Service Information

Mazda Motor Corporation

Category F	Repair Guidance	Ref. No. R050/14A	Page 1 of 6
Coverage <input type="checkbox"/> Distributor only <input checked="" type="checkbox"/> Please inform your dealers		Date Issued June 12, 2014	
Please convey this information to your <input type="checkbox"/> Director <input checked="" type="checkbox"/> General Manager <input checked="" type="checkbox"/> Warranty Dept. <input checked="" type="checkbox"/> Parts Dept. <input checked="" type="checkbox"/> Training Dept. <input checked="" type="checkbox"/> Field Rep.		Date Revised July 10, 2014	
Applicable Model Mazda3 (BM), Mazda6 (GJ) and CX-5 (KE) with SKYACTIV Engine & i-ELOOP		Applicable Countries or Specifications Worldwide (Except North America)

Subject: i-Stop Warning Light flashing, Master Warning Light illumination and a message “i-ELOOP Malfunction” (BM) / “i-ELOOP Inspection Required” (GJ)&(KE) in LCD (DTC P1794)

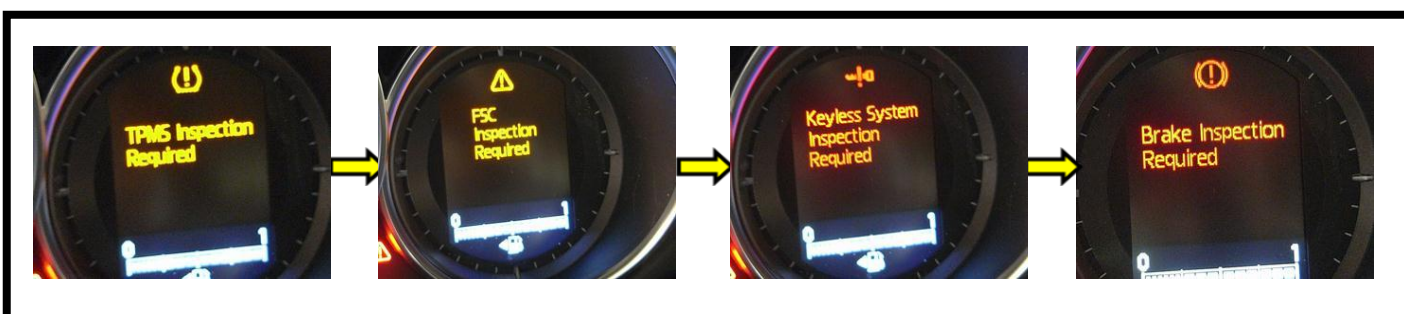
During PCM reprogramming, some vehicles may show some warning messages with flashing Start stop switch. This is caused by reset function of ABS/DSC CU not working properly.

Below warning messages are displayed.

REPAIR PROCEDURE

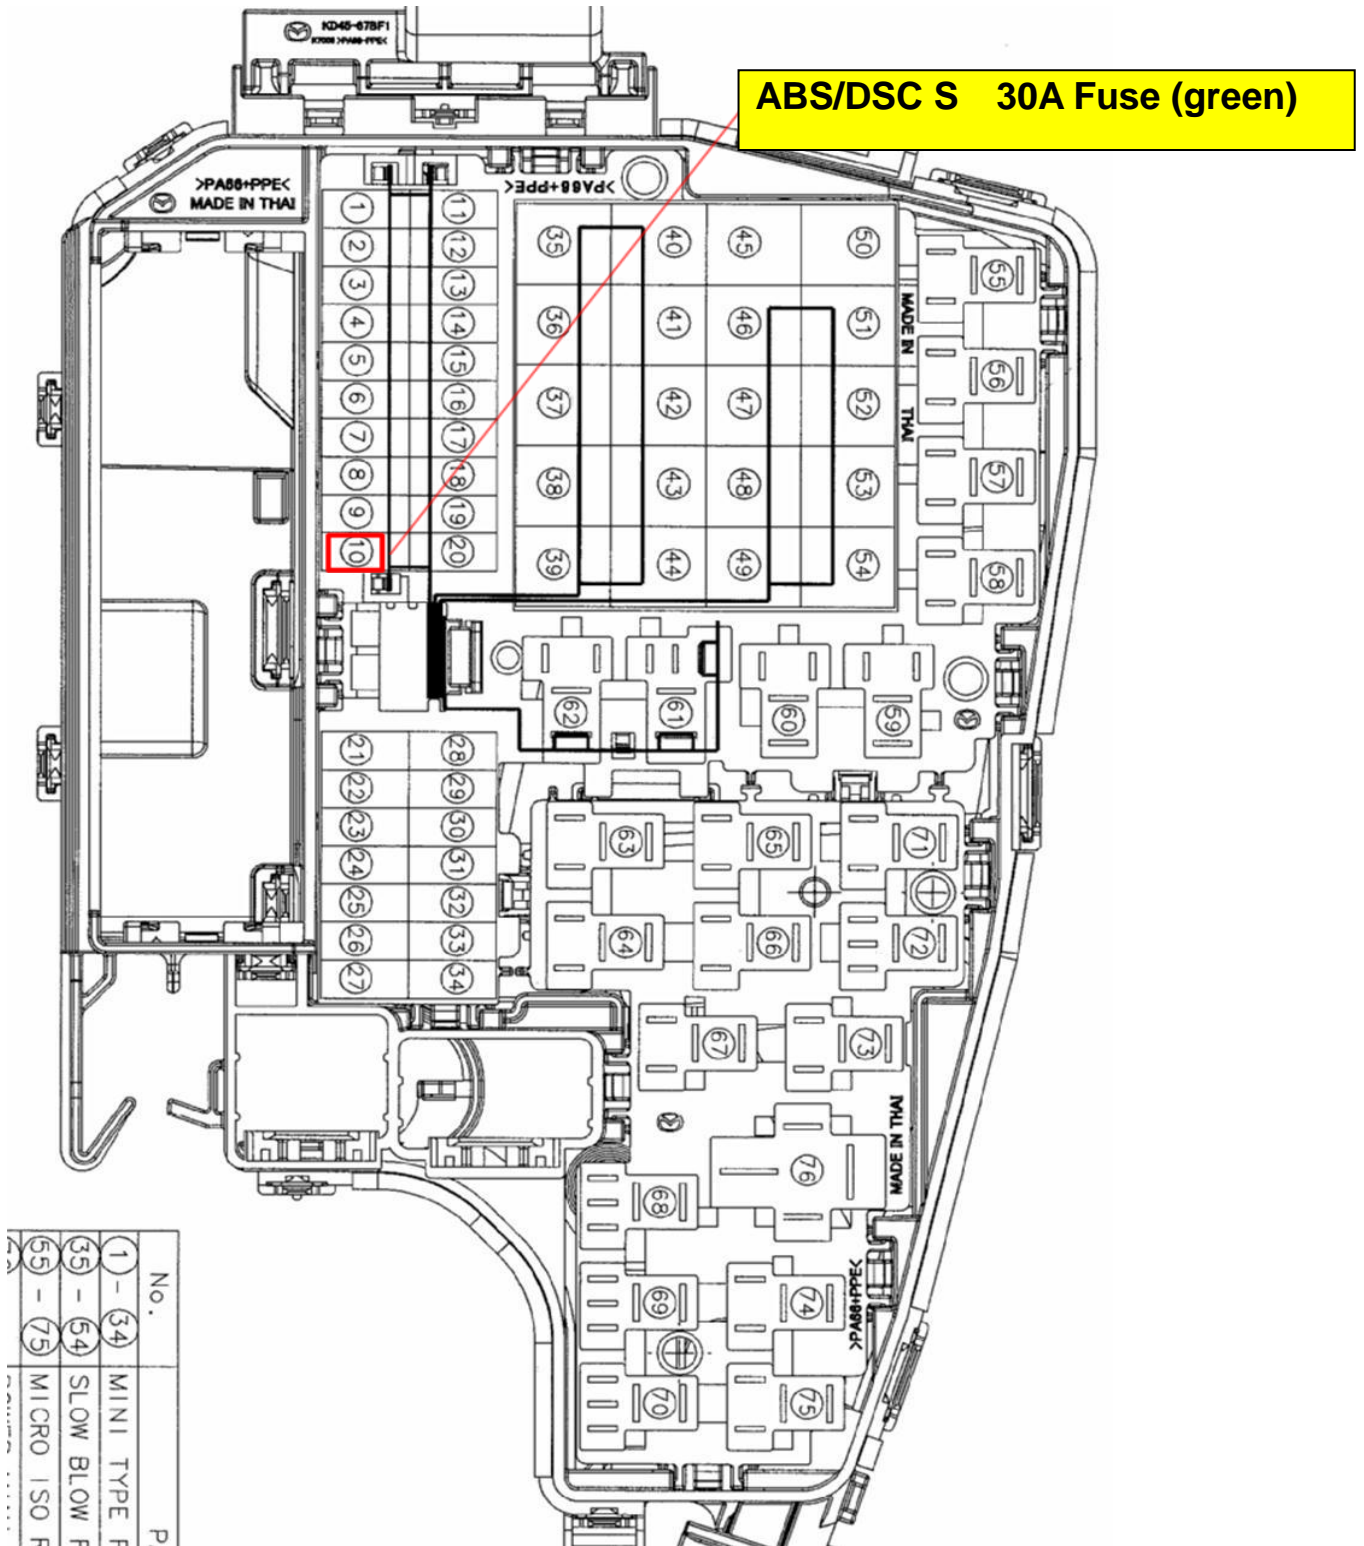
Note: There is similar name fuse "ABS/DSC M 50A, that's wrong one.

1. Turn the IG-off by pushing Start Stop switch for long time (around 3 seconds) to turn off.
2. After that, disconnect **ABS/DSC S 30A** Fuse for 30 seconds so that the system is reset back to normal.
